City of Portland, Maine – Building or Use Permit Application 389 Congress Street, 04101, Tel: (207) 874-8703, FAX: 874-8716

**Sign Permit Pre-Application
Attached Single Family Dwellings/Two-Family Dwelling
Multi-Family or Commercial Structures and Additions Thereto**

BUILDING PERMIT REPORT

REASON FOR PERMIT: Signage

Paradigm

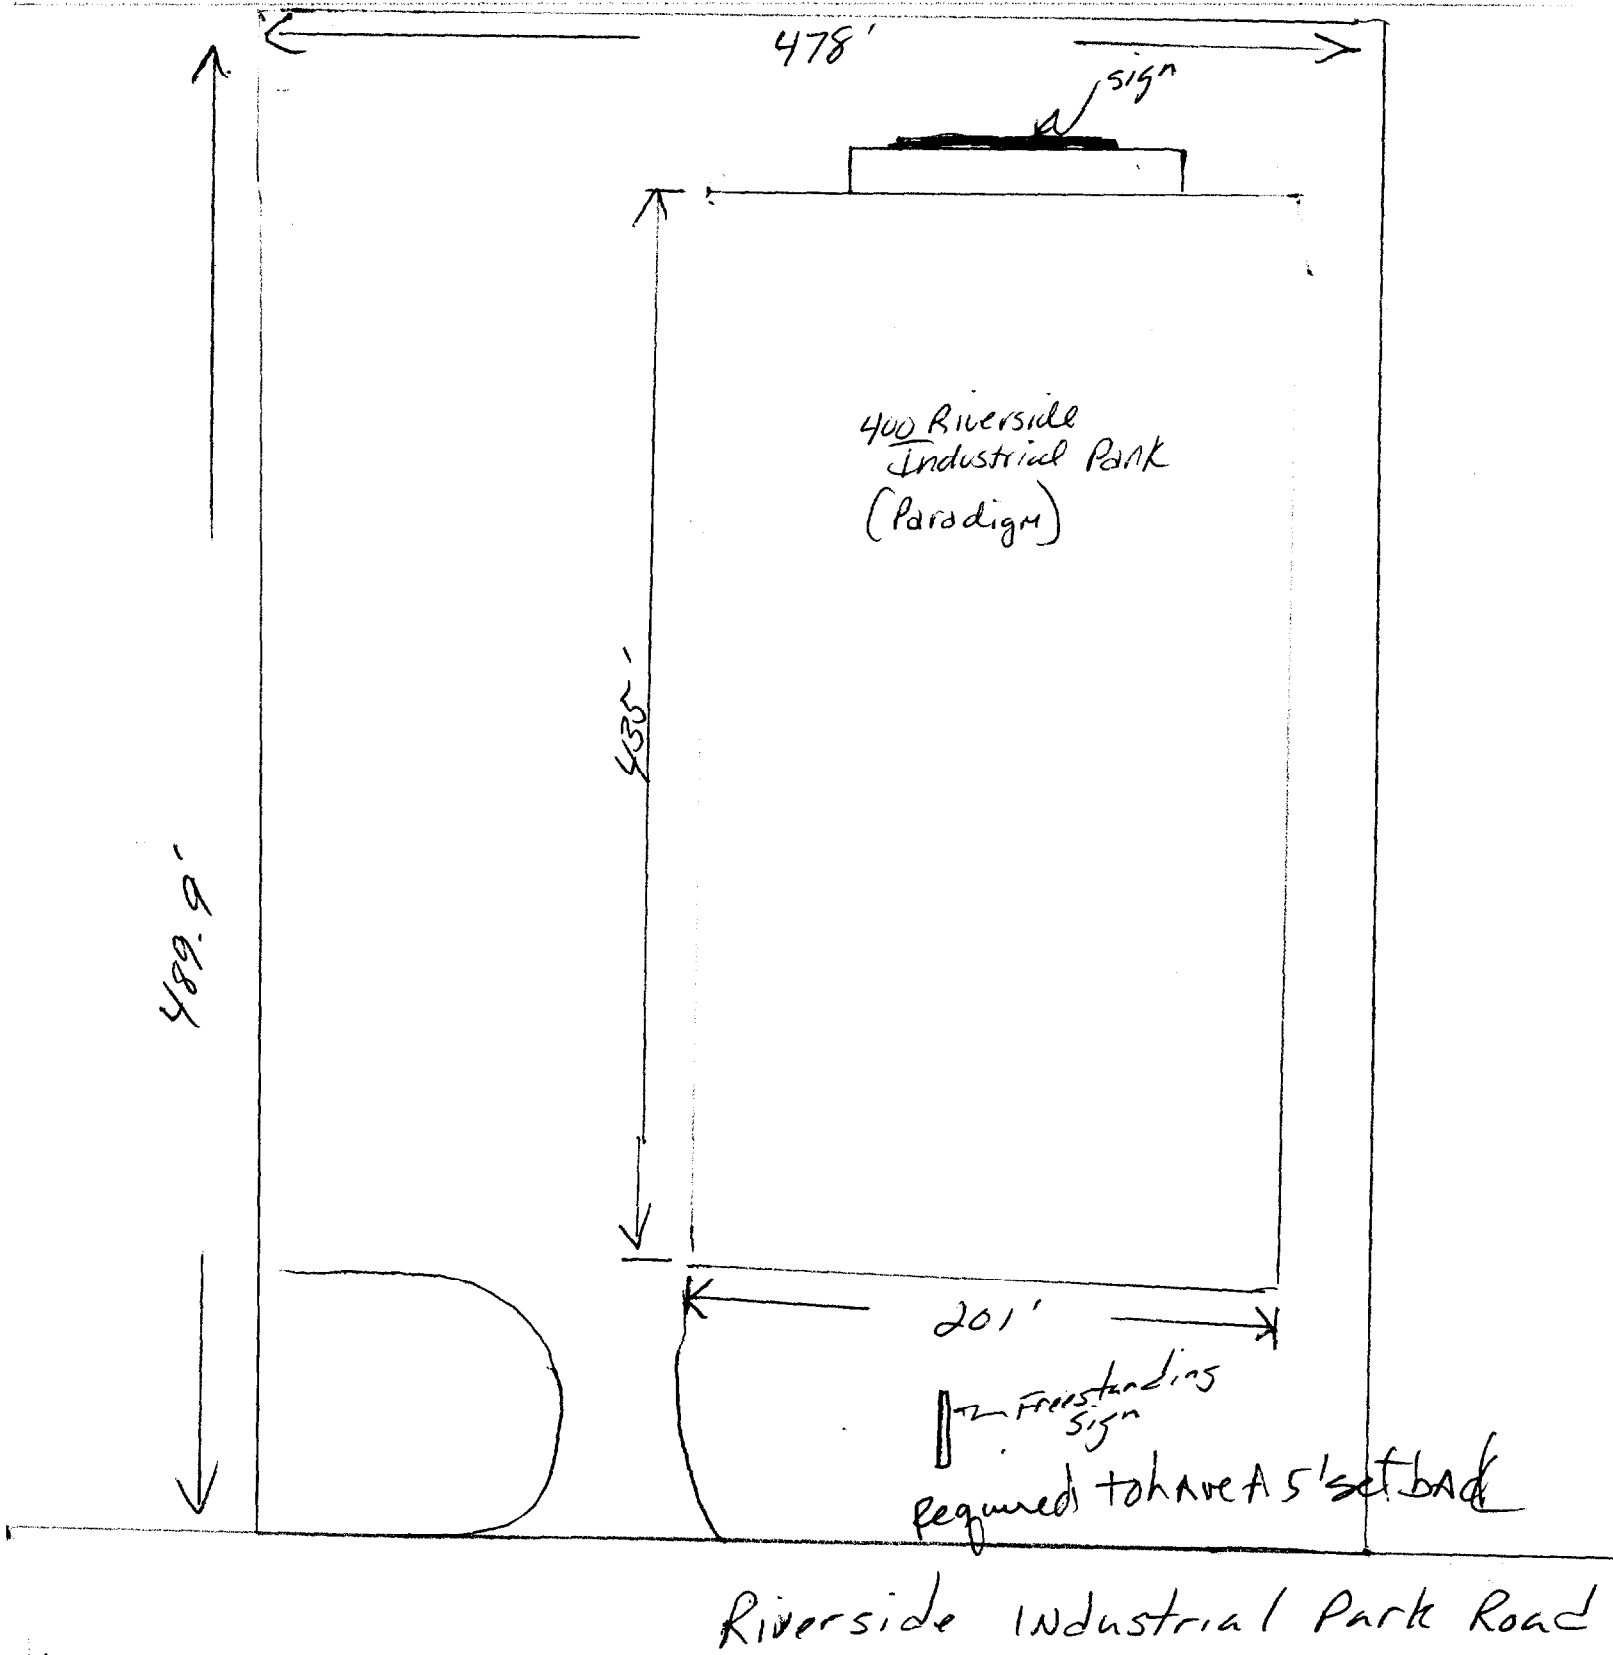
Marge, the buildings roof raises up 12'.
 That section is back from the front edge.
 See attached blue print.
 I measured the wall area in front and
 it was 17.5' x 201' = 3517.5 sq ft

*Test
29.5'
17.5'*

*12
17.5
29.5*

CONCEPT DRAWING
(1) SET OF CHANNEL NEON LETTERS

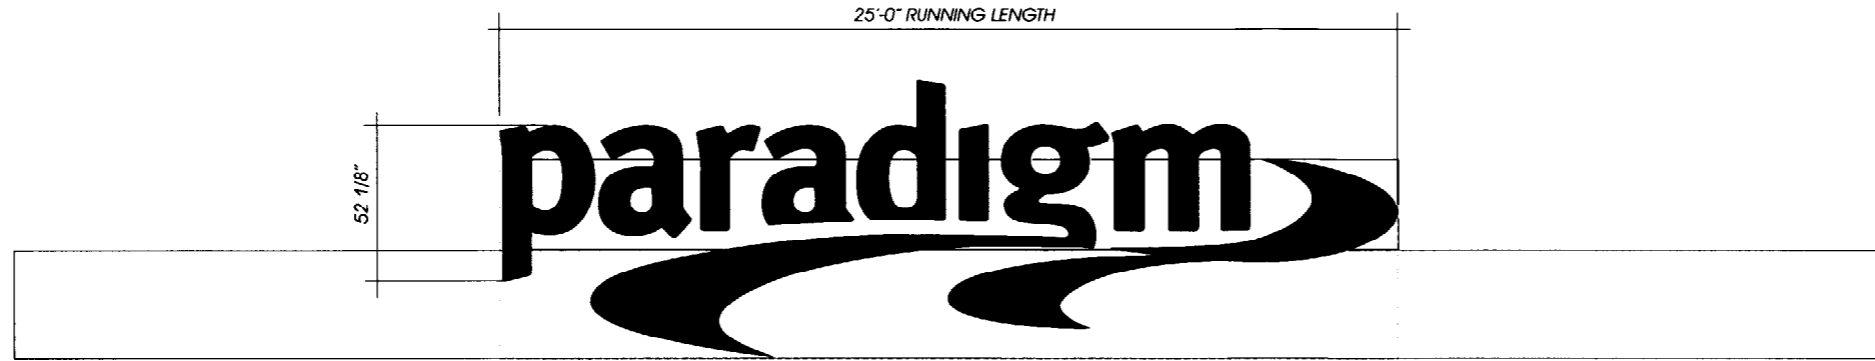
*1/8/01
A lower canopy
per contractor,
Rodney Beam
to phone in the
height of the
main bldg*

CONCEPT DRAWING
 (1) D.F. 3'-3" X 10'-9" X _____ " INTERNALLY ILLUMINATED PYLON

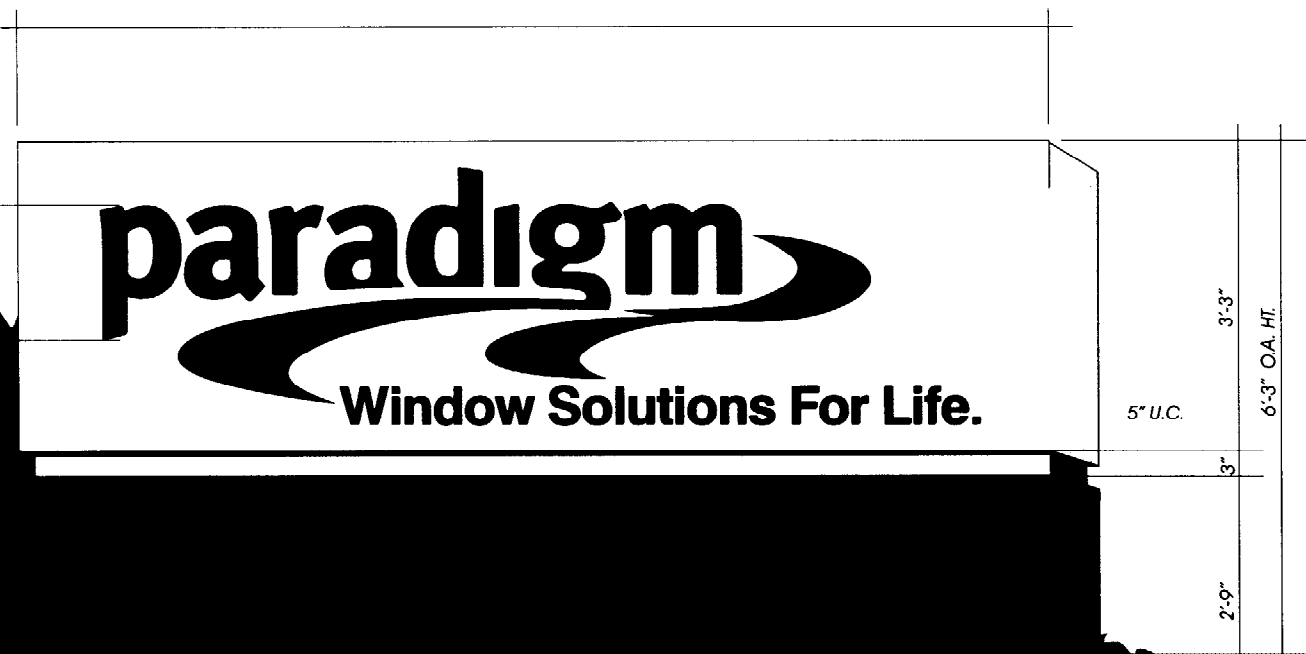
Single tenant Bldg
Free Standing Sign
Allowed 35'
10' high
5' setback
Show: 34.9375'
4.25' high
no setback Show
shall be a req.

The free standing sign shall be set back five (5) feet from the front property line.
